**I-75 @ US 41/US 76/SR 3 (Rocky Face)
Interchange Reconstruction**

NH-0000-00(931)

Whitfield County

**Value Engineering Study Report
Design Development Stage**

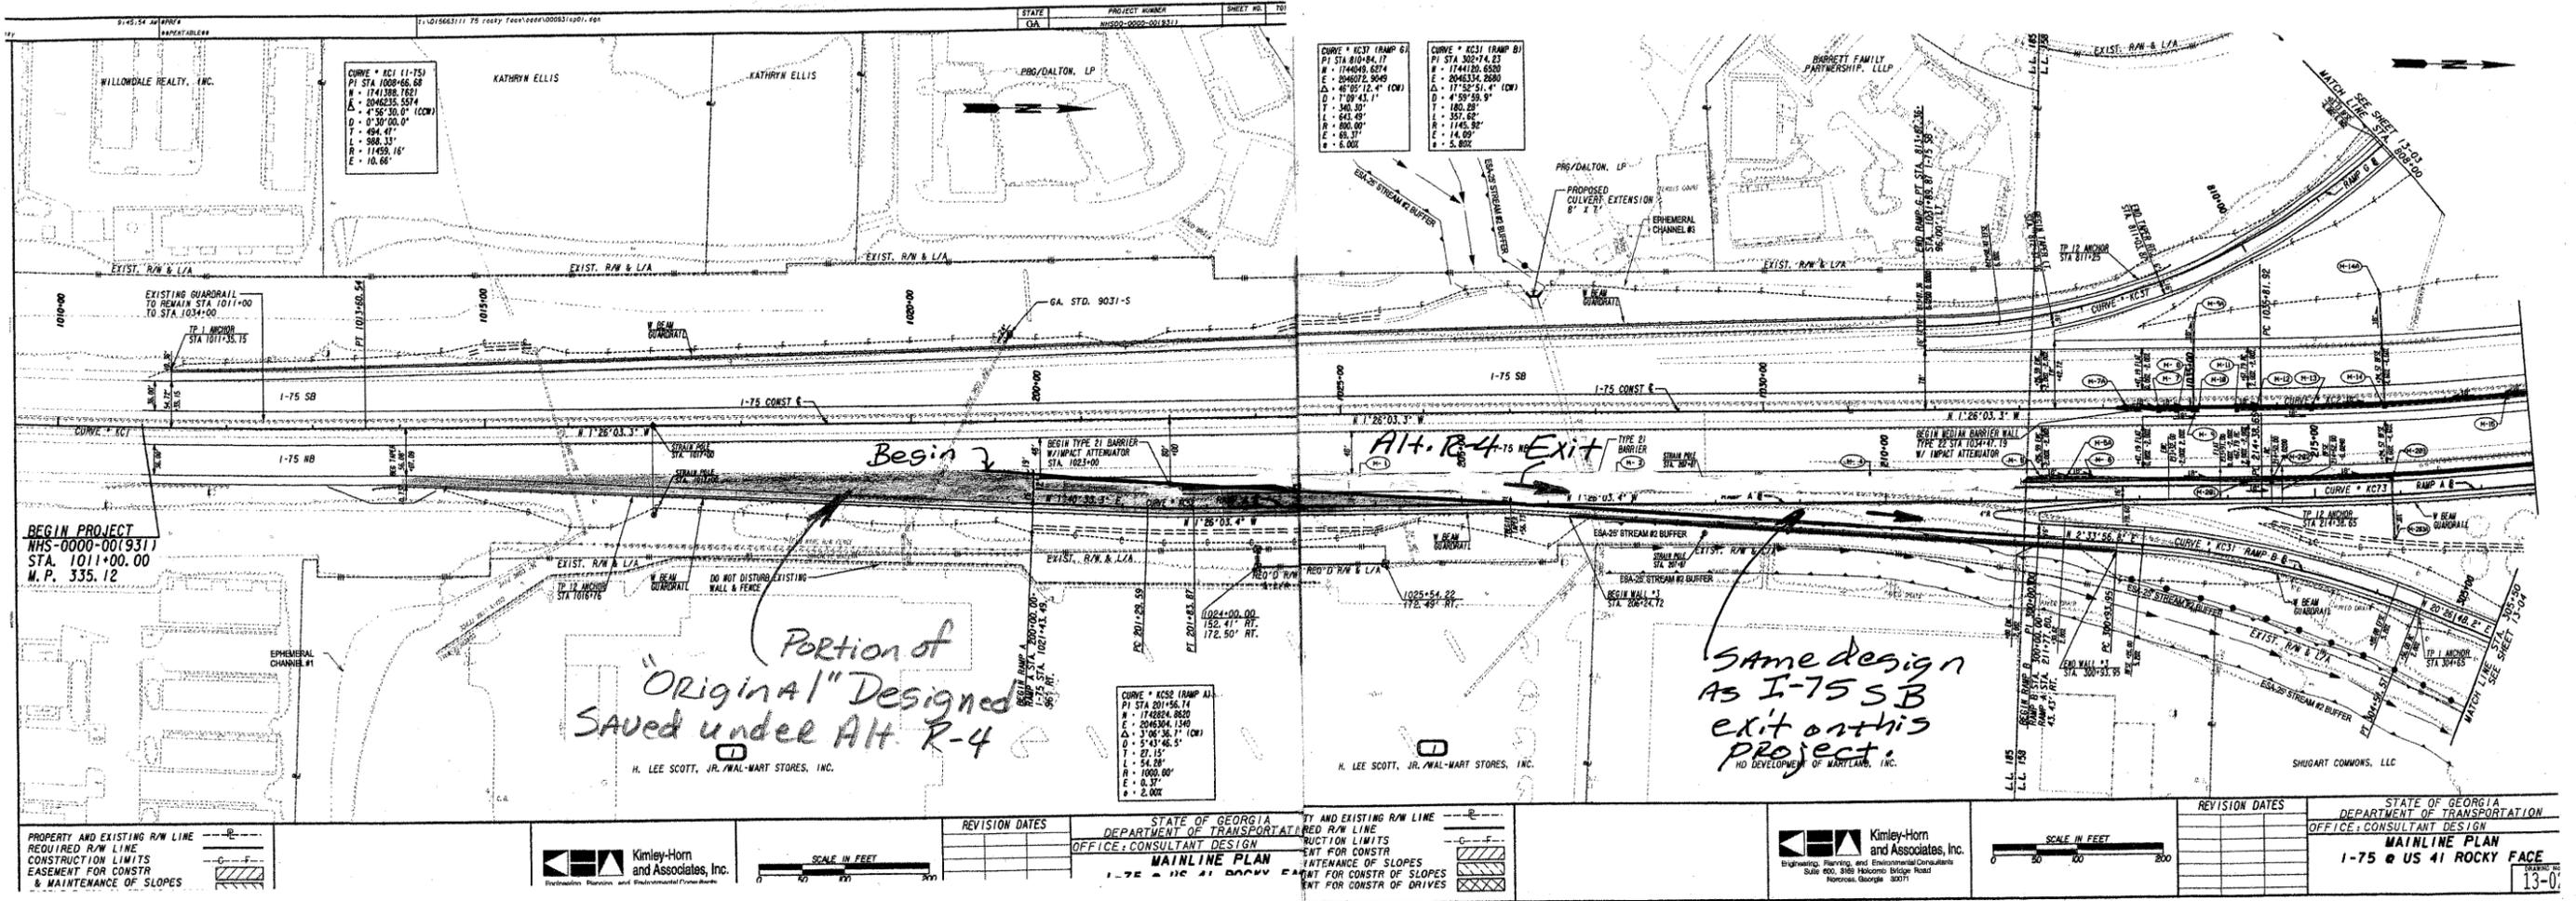
- Shorter decision length for travelers heading eastbound or westbound

The alternative standard design freeway exit being recommended is currently being used on this project for the I-75 southbound exit Ramp F. This alternative would accomplish the goal of increasing capacity, reducing congestion, and improving circulation and save a substantial amount of asphalt pavement and median barrier.

Sketch R-9
 Alternate Design
 Sheet 2 of 4

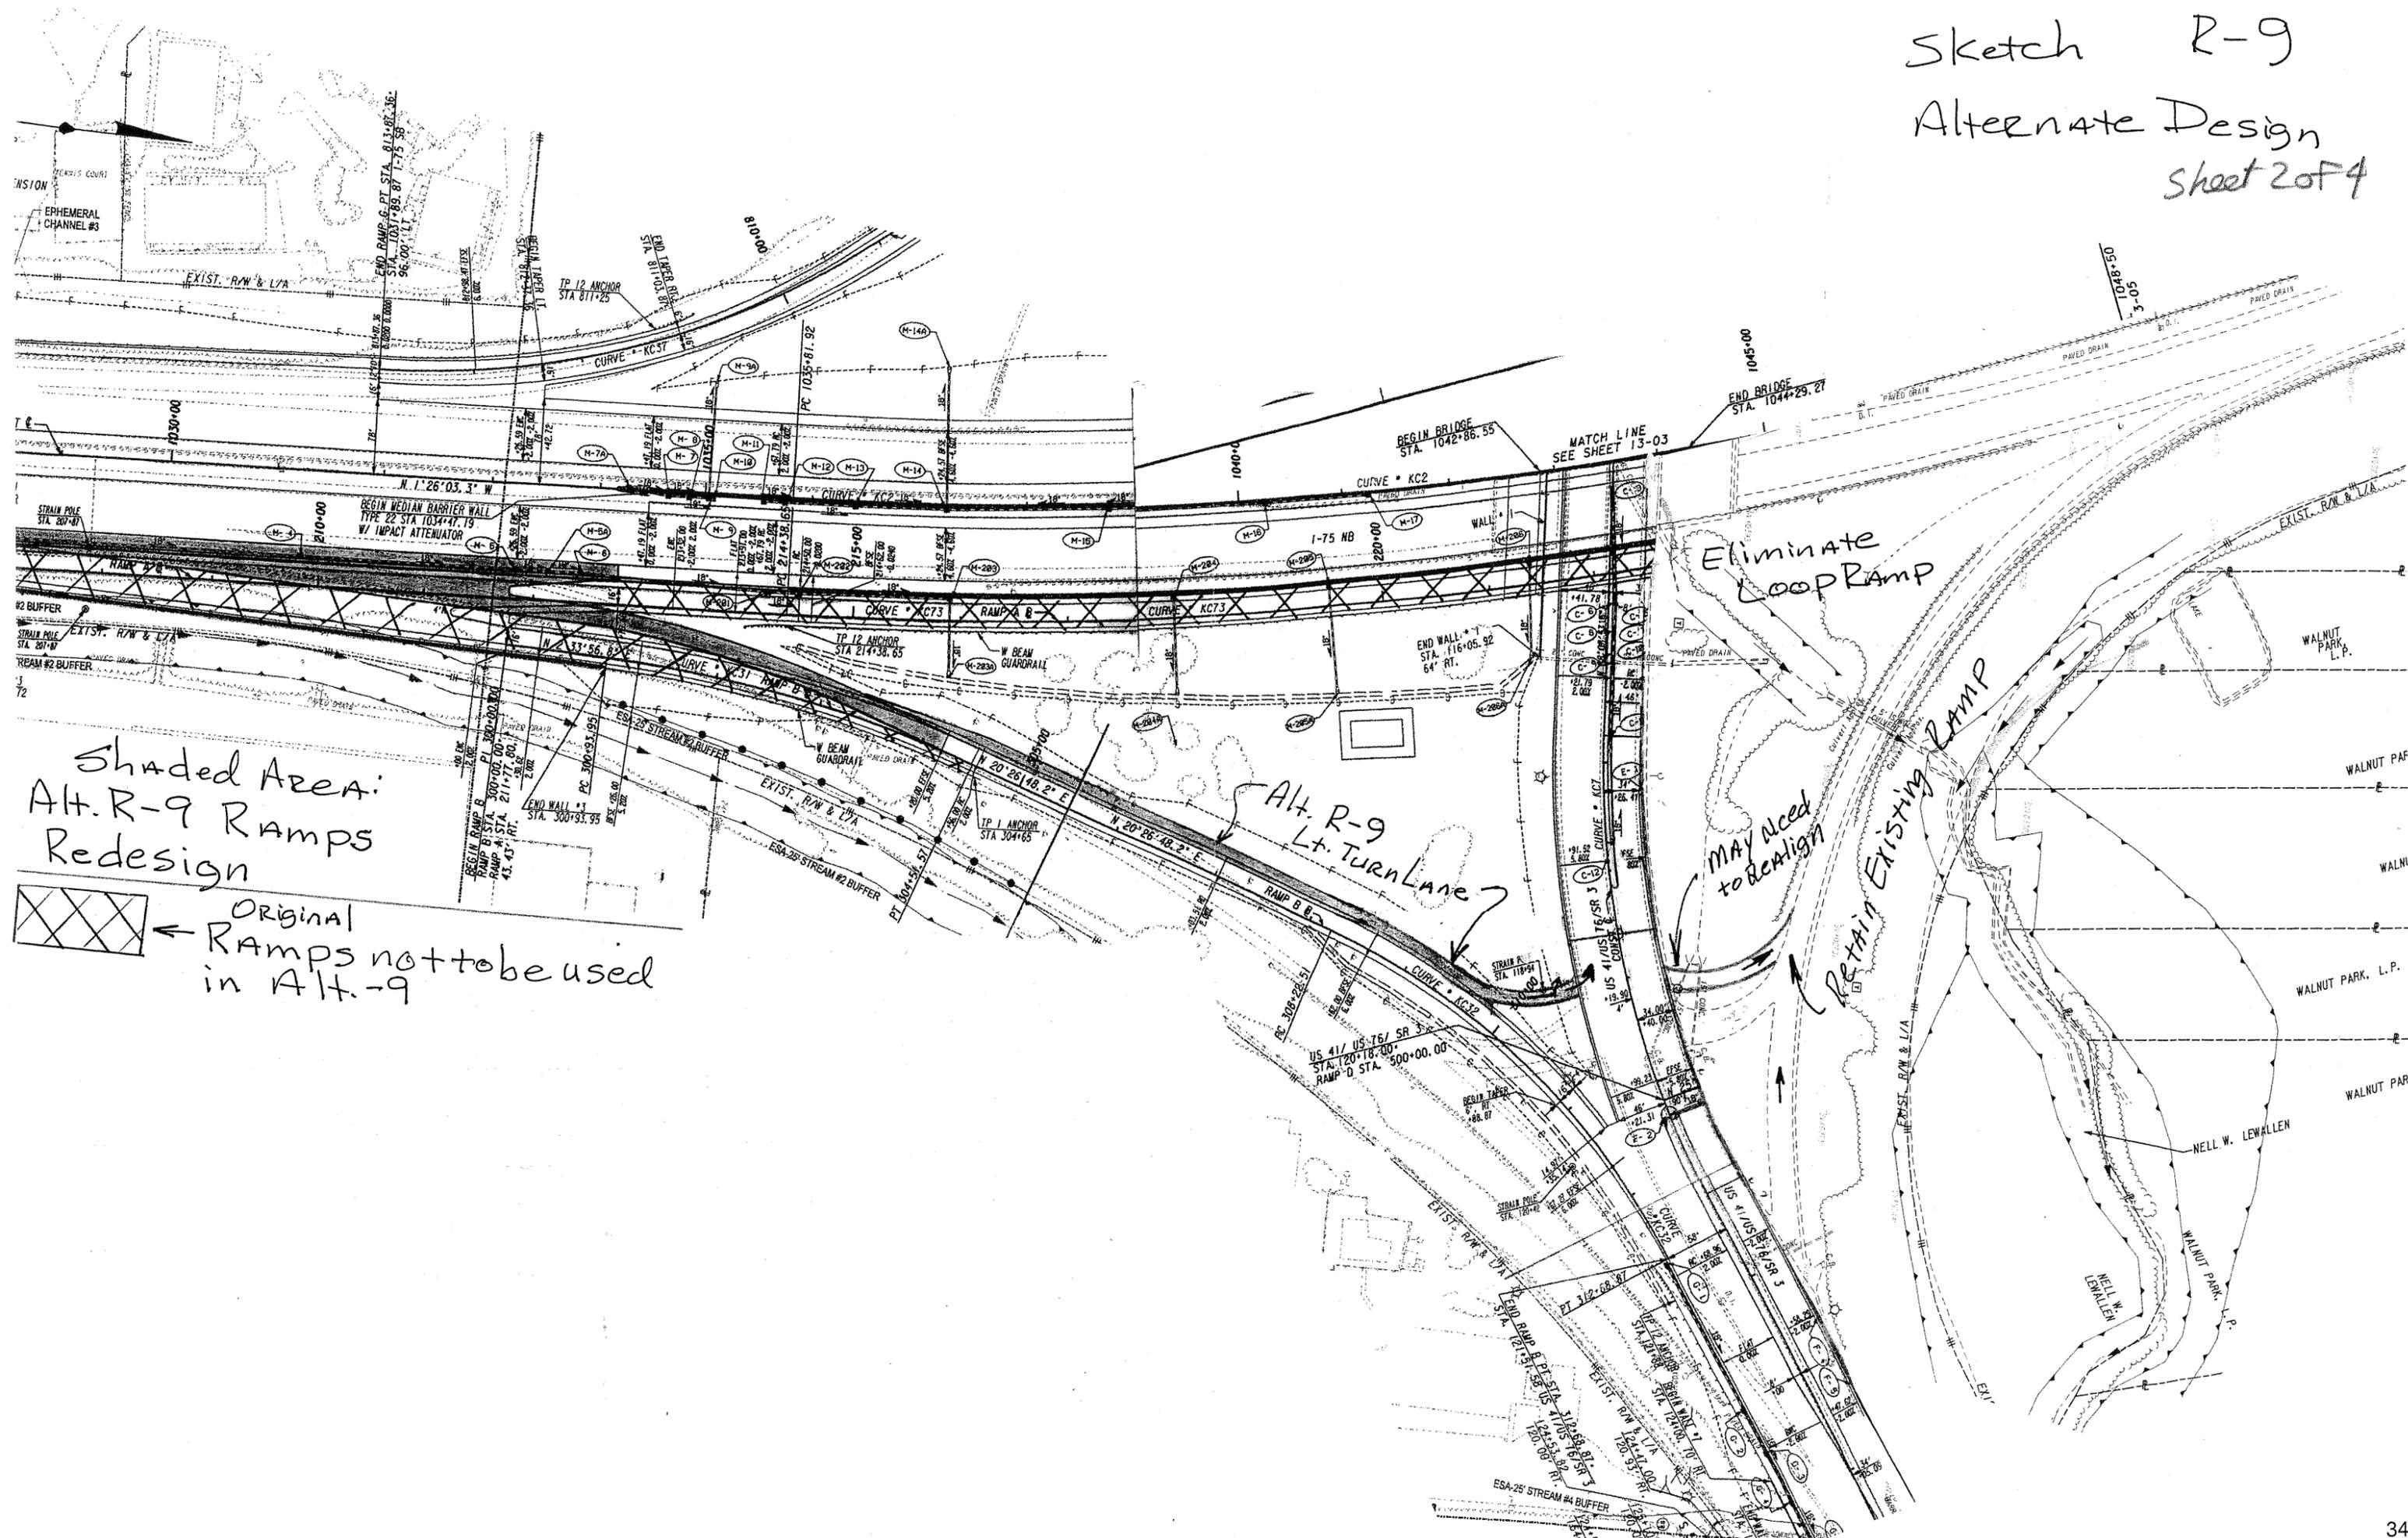
Shaded Area:
 Alt. R-9 Ramps
 Redesign

Sketch
R-10
Alternate
Design sheet 2 of 4

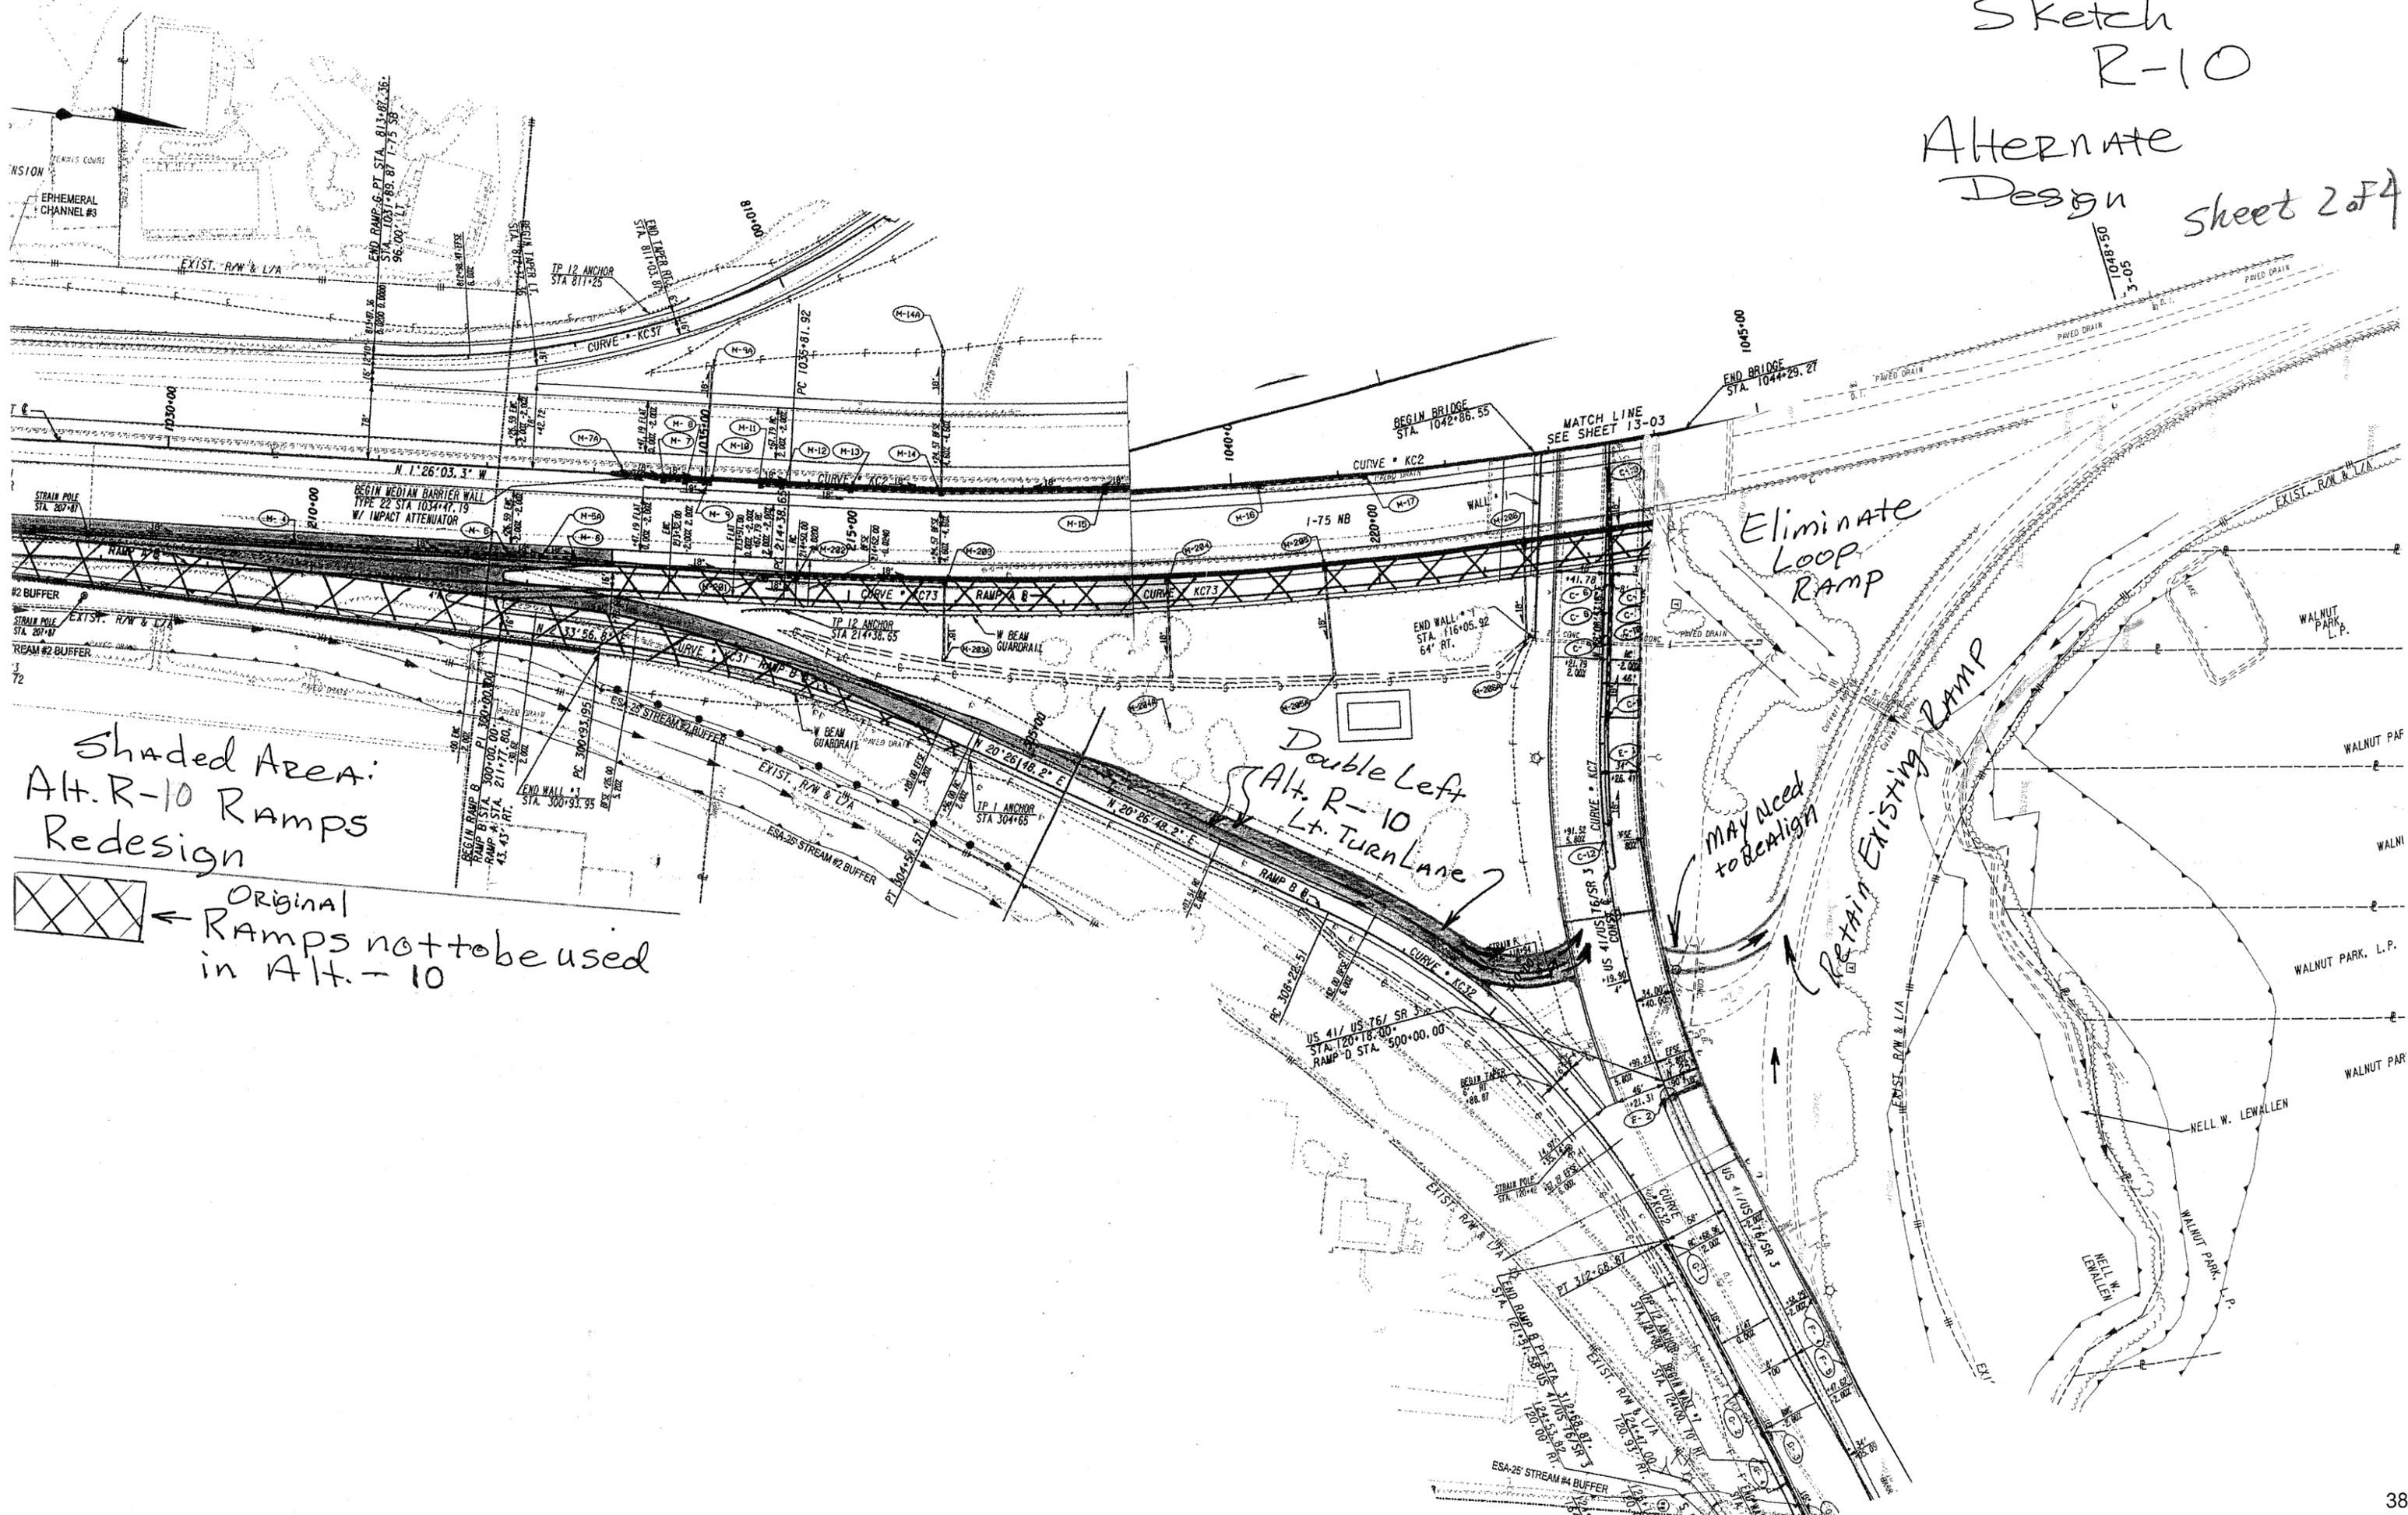
PROJECT:	P.I. No. 0000931, I-75 @ US 41/US 76/SR 3 (Rocky Face) Interchange Reconstruction <i>Whitfield County, Georgia Department of Transportation, District 6</i> <i>Design Development Stage</i>	ALTERNATIVE NO.: R-10
DESCRIPTION:	ELIMINATE LOOP RAMP A BY WIDENING RAMP B FOR DOUBLE LEFT TURNS	SHEET NO.: 1 of 4

Shaded Area:
Alt. R-10 Ramps
Redesign
